11.0 WATER RESOURCES RESPONSES

Figure 11-2
AREAL GEOLOGY

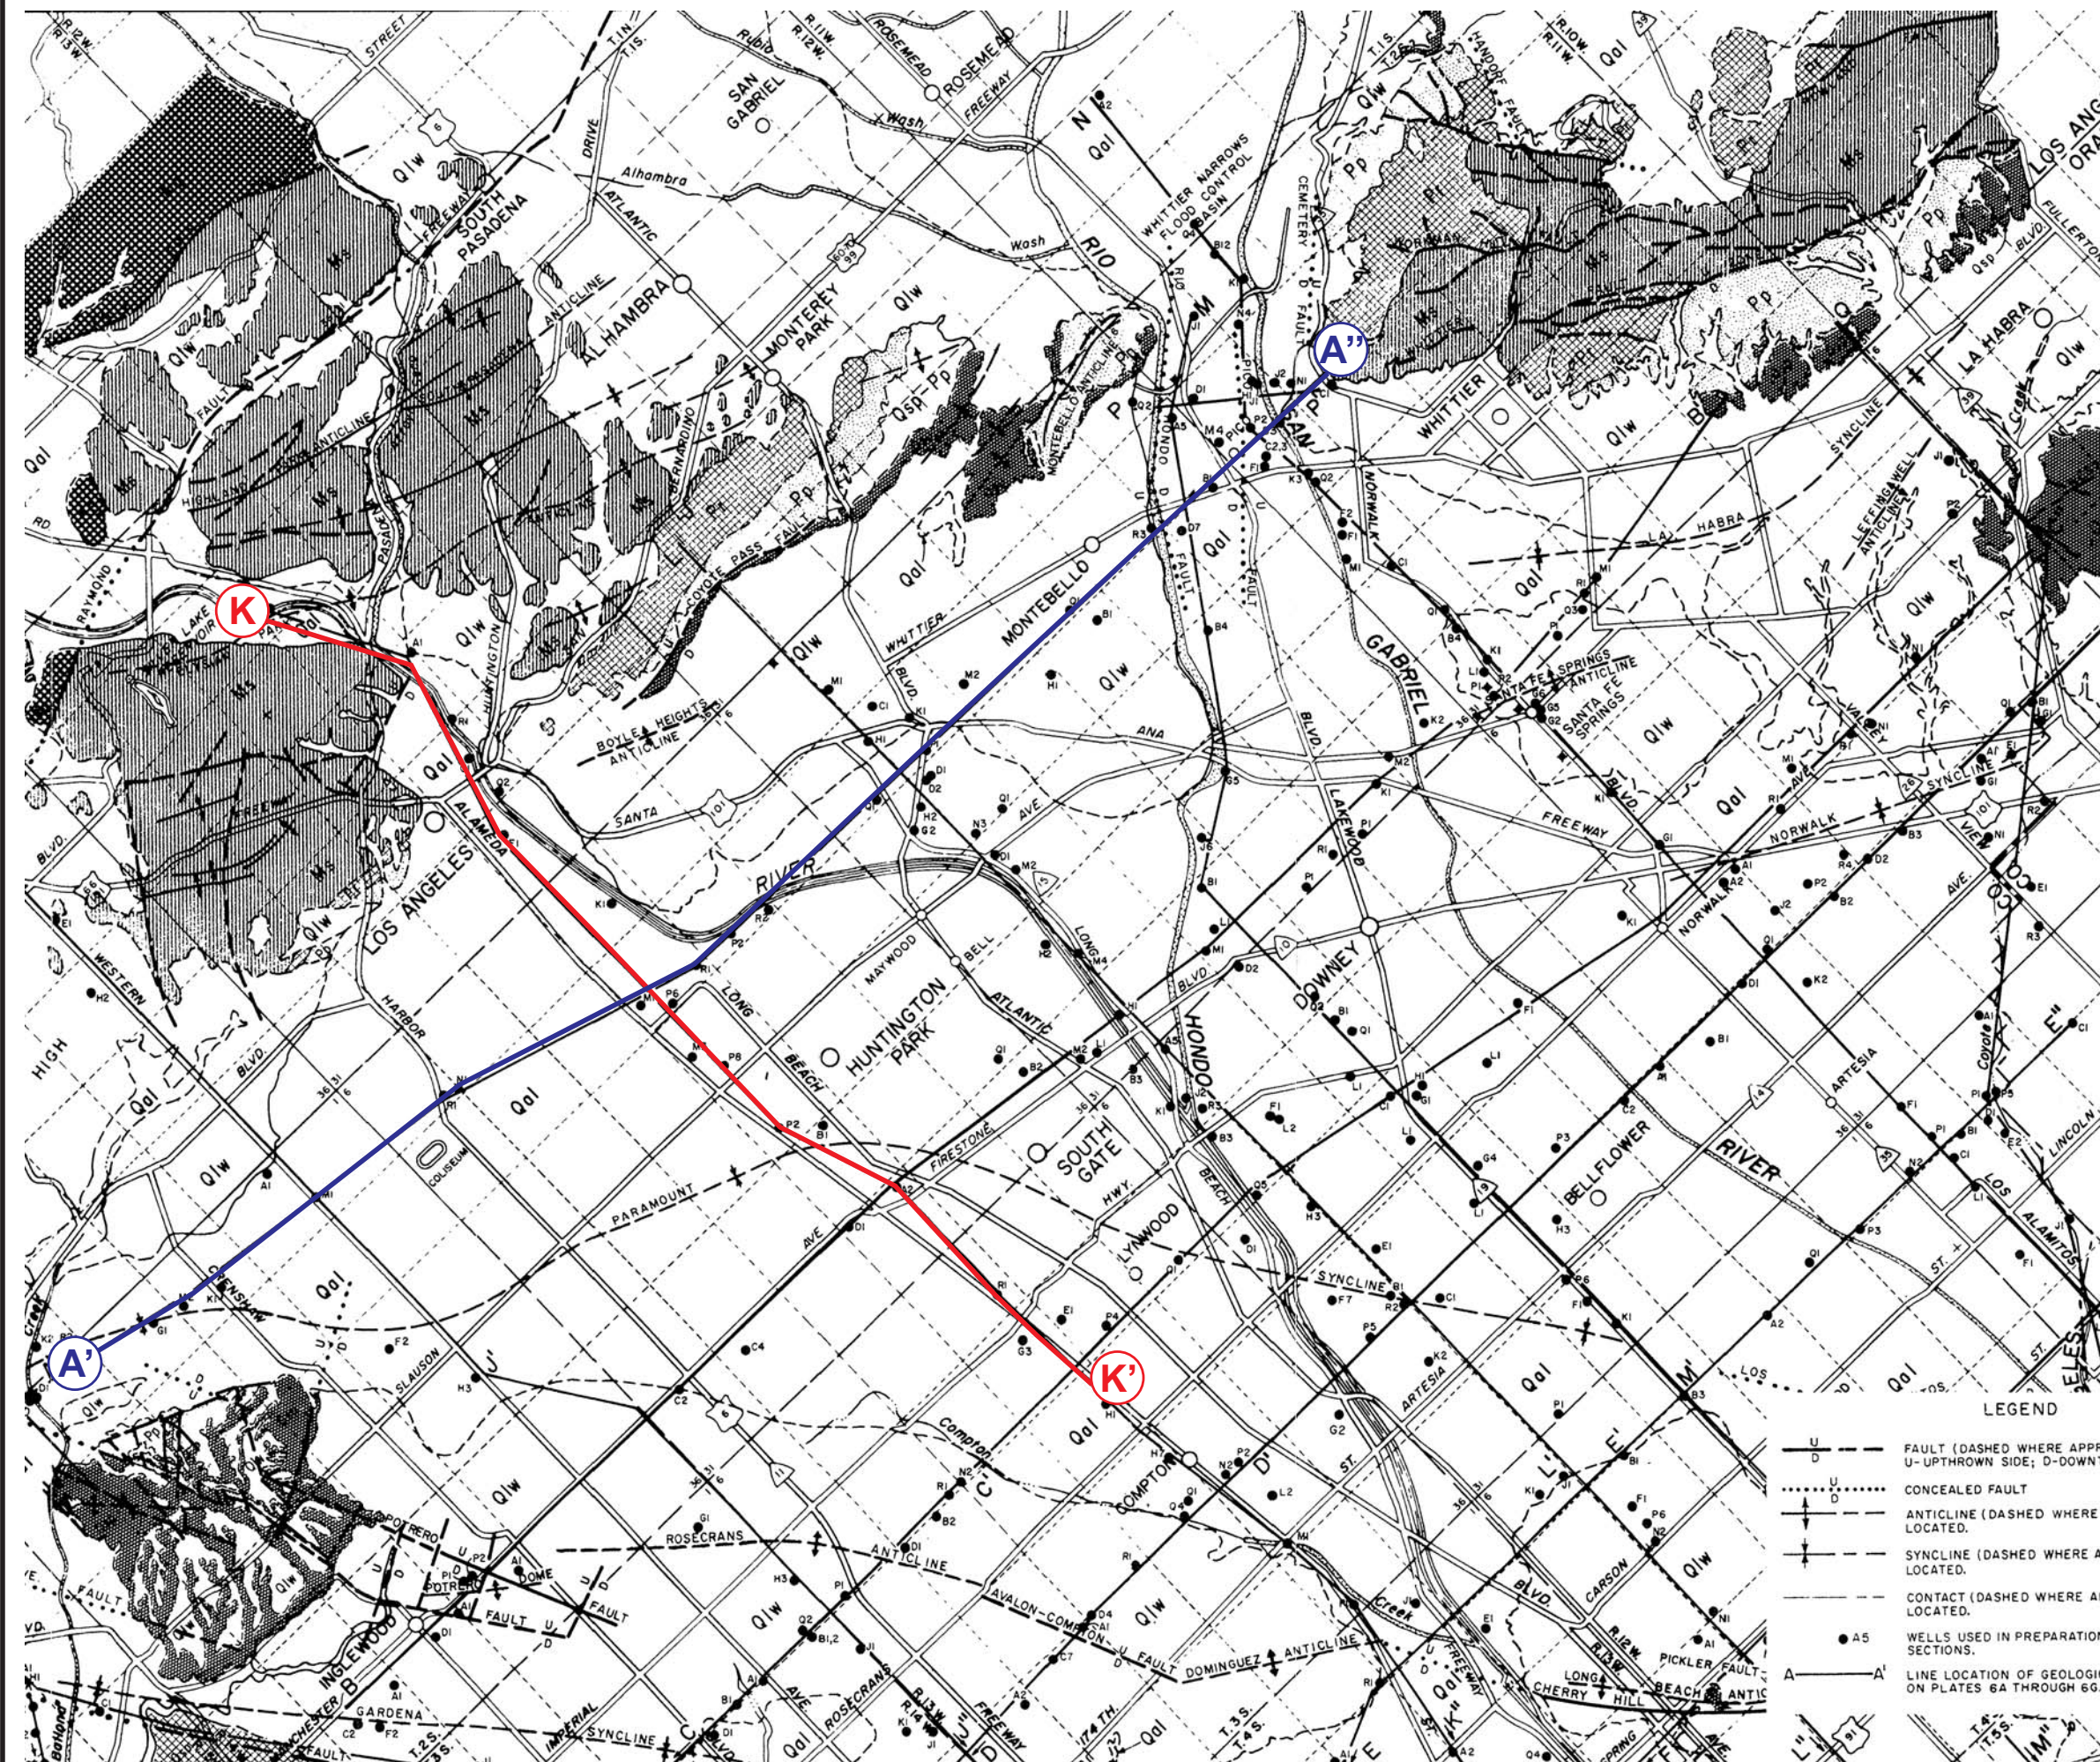
Please provide a hydrostratigraphic map at the appropriate scale of the groundwater bodies and related geologic structures.

Please provide a clearer copy or enlarged copy of Figures 11-2 & 3. Please show the location of K-K' and A'-A" on Figure 11-2.

The two maps in Figures 11-2 and 11-3 show the aerial view and the idealized geologic sections (hydrostratigraphic) of the project vicinity. Cross sections K-K' and A'-A" are just west and north of the project site respectively. These maps were obtained from the Planned Utilization of the Groundwater Basins of the Coastal Plain of Los Angeles County: Bulletin No. 104, Appendix A Groundwater Geology (Reprinted April 1988), 181 pp., 52 plates (Department of Water Resources, 1961).

Clear copies of Figures 11-2 & 11-3 are provided. The location of K-K' and A'-A" are also shown on Figure 11-2

FIGURE 11-6
EXISTING SITE DRAINAGE PLAN

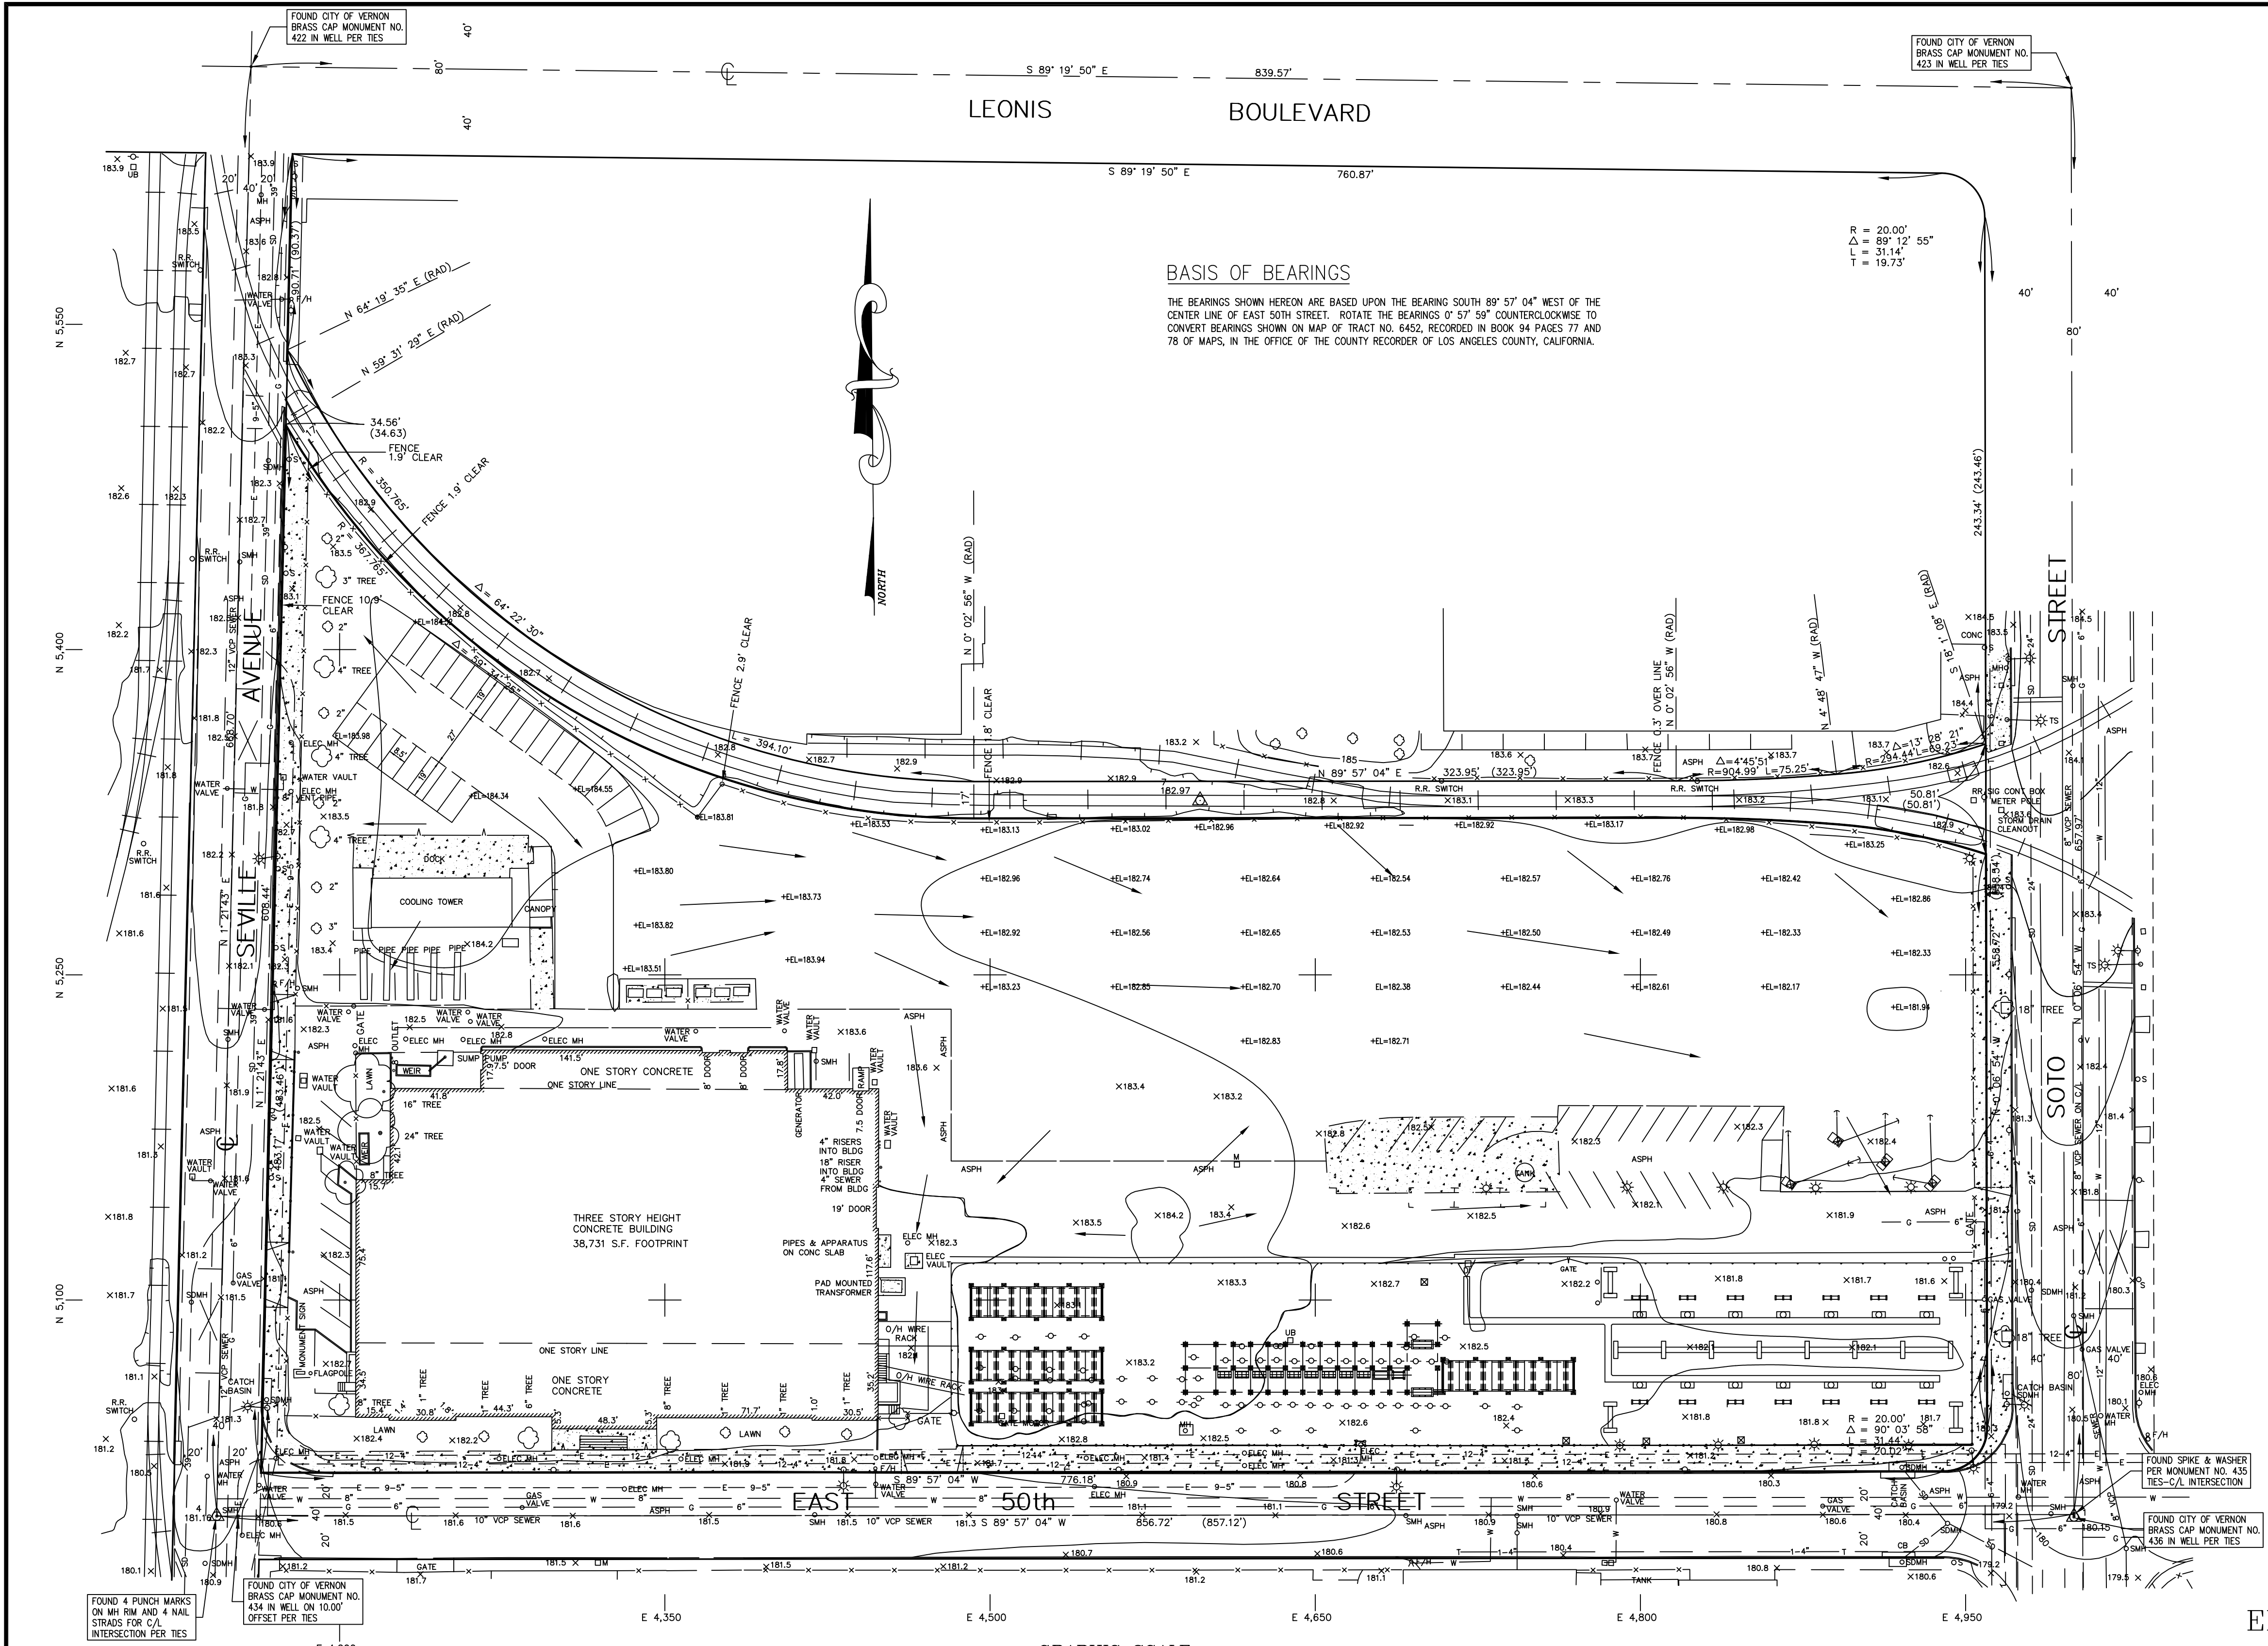
Please provide pre-construction runoff and drainage patterns.

Please provide pre-construction run-off and drainage patterns. Figure 11-6 of the supplement is blurred and unclear. A colored copy with more contour lines or a first generation copy would be helpful.

The current site has been cleared and the soil has been compacted. The cleared area for the new plant has been crowned in the middle with a 1-foot drop to the edge of the property. The site is surrounded by a sidewalk and curb. The existing runoff design is still maintained, most of the storm water will be absorbed on the site. Excess storm water will runoff the site to the east and west and enter the current stormwater drains in the street.

Figure 11-6 shows the existing grade and has been modified to include the estimated directional flow for pre-construction runoff and drainage patterns.

The old Figure 11-6 has been replaced with the new Figure 11-6.
